# **National Electrical Safety Code**

## **Interpretations**

**1961—1977 inclusive**

This edition includes official interpretations of the National Electrical Safety Code as made by the Interpretations Subcommittee of the National Electrical Safety Code Committee, ANSI C2.

Fig IR 93.

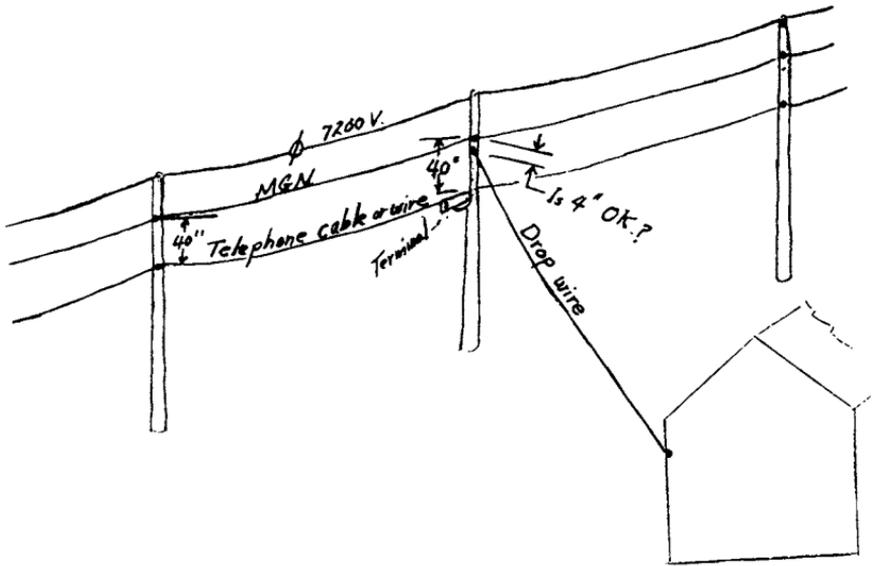
Rule 238D, Exception 2, of the Sixth Edition of the National Electrical Safety Code states that communication service drops which "*cross under* supply conductors on a common crossing pole" may have a separation of 4 in from "an effectively grounded supply conductor." We should like to know whether this rule may be interpreted as permitting a 4-in separation between a multi-grounded neutral and telephone drop attached to and distributing from a joint use pole as indicated in the enclosed sketch. If it is permissible to run drop wires vertically up a joint use pole to within 4 in of the multi-grounded neutral, it would be of considerable value in obtaining ground clearance over rods, etc., without requiring additional pole height. We can see no difference from a safety standpoint in the construction shown in the sketch, as compared with the construction that seemed to have been contemplated by the wording of this exception.

Fig IR 103-1.

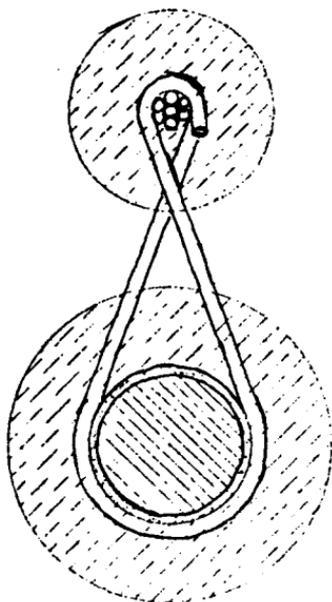
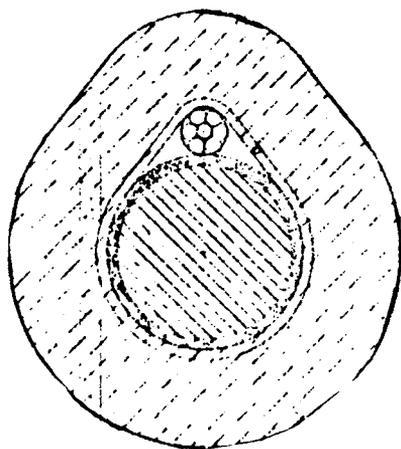
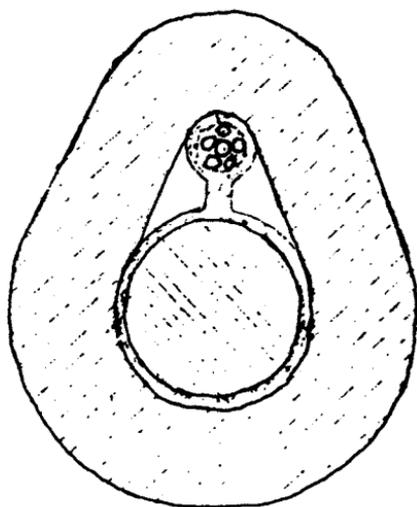
Rule 251 was written when telephone cable was suspended by rings a few inches below the supporting messenger strand. See Figure 1 on the attached sketch. In this case, the supporting strand can be completely surrounded by ice and also the messenger strand can be completely surrounded by ice.

However, at present, telephone cable is either lashed to the messenger as shown by Figure 2 of the attached sketch or the supporting strand is an integral part of the Figure 8 type cable as shown by Figure 3 of the attached sketch. In both these cases, since the cable is held so close to the messenger strand, there is only one circumferential covering of ice, whereas, with the old method of cable supported by rings there were two circumferential coverings of ice, one for messenger strand and one for the cable.

For this reason, it is our opinion that for both lashed cable and Figure 8 cable only one constant (that for weatherproof, etc.) should be added to the resultant loading as specified in Rule 251.

In several cases, engineers, when making sag and tension calculations, have in the case of Figure 8 cable (Fig 3) used only one constant on the premise that the supporting strand was an integral part of the cable. If this is correct for Figure 8 type cable, it should also be correct for lashed cable (Fig 2) and only one constant should be used.

It will be noted that for cable suspended by rings, the difference in the resultant loading for 8 lb of wind (Fourth Edition) and the resultant loading for 4 lb of wind plus *two* constants is  $3.138 - 3.075 = 0.063$  lb/ft. For the lashed cable with only *one* constant, the difference is  $2.364 - 2.250 = 0.114$  lb/ft and for Figure 8 cable with only *one* constant, the difference is only  $2.473 - 2.335 = 0.138$  lb/ft. Also, it is common practice to spiral both lashed cable and Figure 8 cable when erected in place to reduce the tendency of cable dancing. This spiraling will reduce the projected area exposed to wind pressure since the area of the messenger strand will only add to area exposed to wind pressure for one half of the length. Therefore, the difference between the resultant with 8 lb wind and the resultant with 4 lb wind plus one constant for lashed cable and Figure 8 type will be further decreased.

Comparison of the resultant loading for lashed cable and Figure 8 type cable with the 8 lb wind loading and the 4 lb wind loading plus *two* constants show the latter to be excessive.

For these reasons, it is recommended that for lashed cable and Figure 8 type cable that only one constant be added for the combined messenger and cable to the resultant with 4 lb of wind pressure per sq ft.

The Committee's interpretation of the application of Rule 251 (NBS Handbook 81) to lashed cable or figure 8 cable is that loading should be calculated in accordance with the method outlined in the Fourth Edition of the National Electrical Safety Code.

The general intent of the rule change which was made between the Fourth and Fifth Editions was to retain essentially the same conductor loading but reduce the transverse loading. As Mr. Holmes calculations indicate, Fourth Edition loading on ring supported cable is very nearly the same as Fifth (or Sixth) Edition loading. Literal application of the Fifth Edition loading rule to lashed and figure 8 cable results in loading which is heavier than Fourth Edition loading. Using Fifth Edition values of wind and ice with a single constant produces loading which is less than Fourth Edition values. This is perhaps to be expected since we are using a formula for something its authors had not visualized.

Fig IR 199-1.

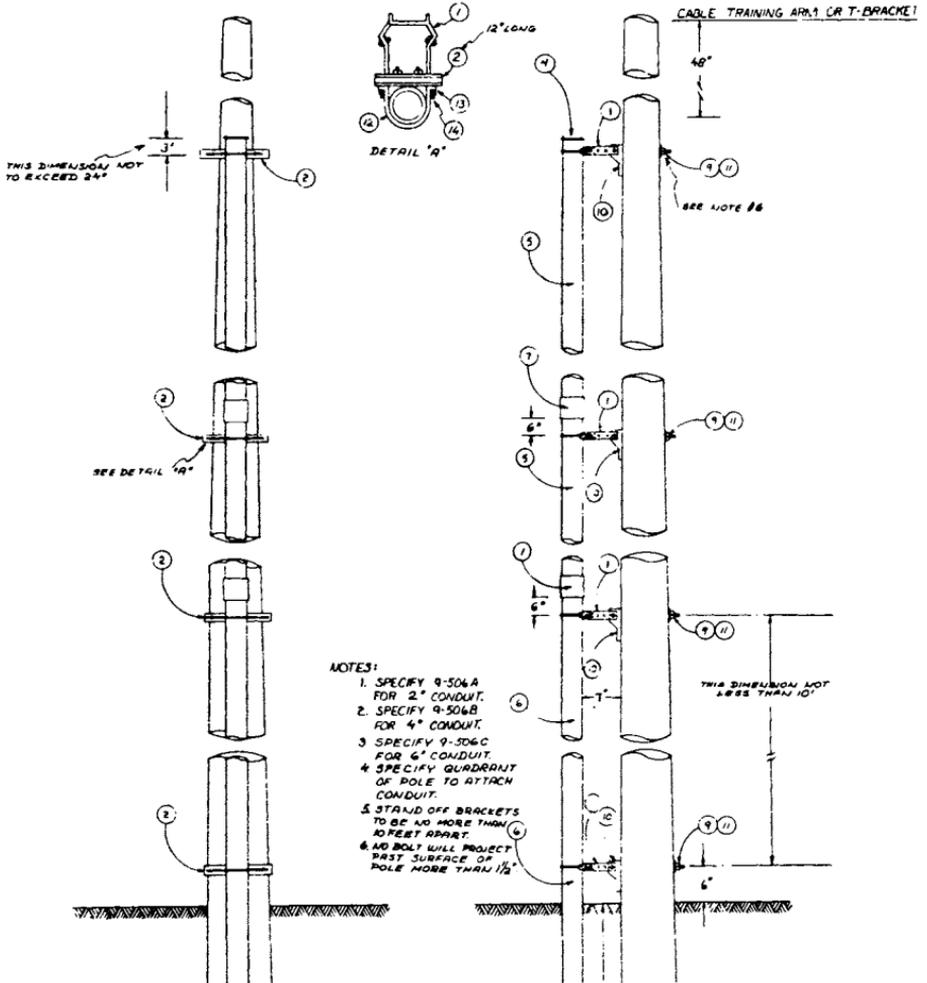
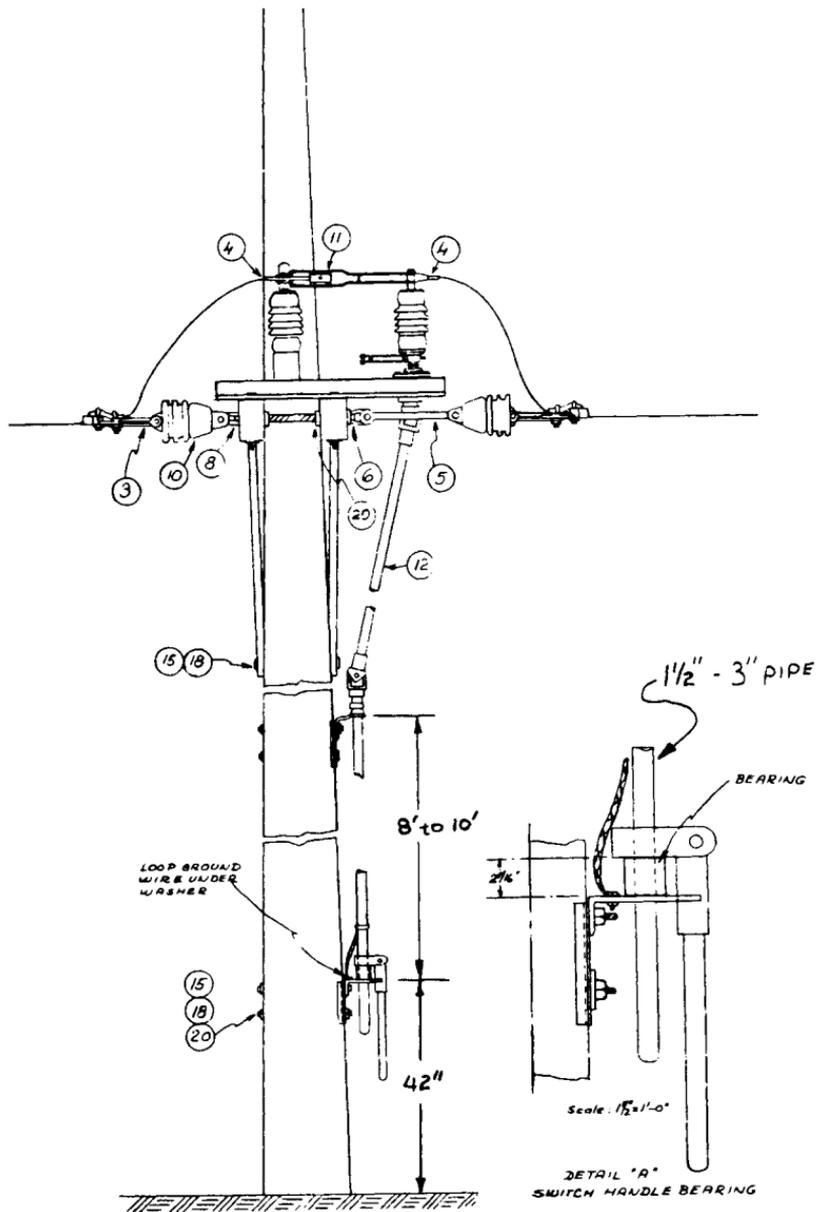
Enclosed are two prints showing our standard construction practices. Are these or similar structures considered “readily climbable” by unauthorized persons?
